CONTRACT AMENDMENT NO. 5 TO 2016-03 ROAD BOND & ROAD REHABILITATION PROJECT

CONTRACT AMENDMENT NO. 5

Examples of Road Base Conditions

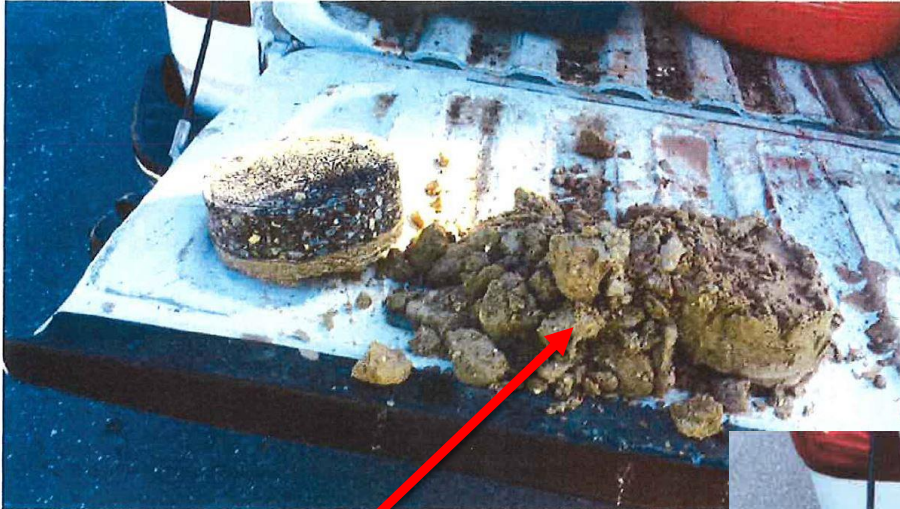
- ***Change in Scope:*** The original contract only includes minor base repairs. The proposed work on North Port Boulevard will require complete base replacement which changes the scope of the project.

- ***Change in Price:*** The prices included in the original contract are for base repairs only. The proposed work on North Port Boulevard requires complete base replacement (remove existing asphalt and base and replace with 5" of asphalt overlay and 1" of base) which increases the total contract price.
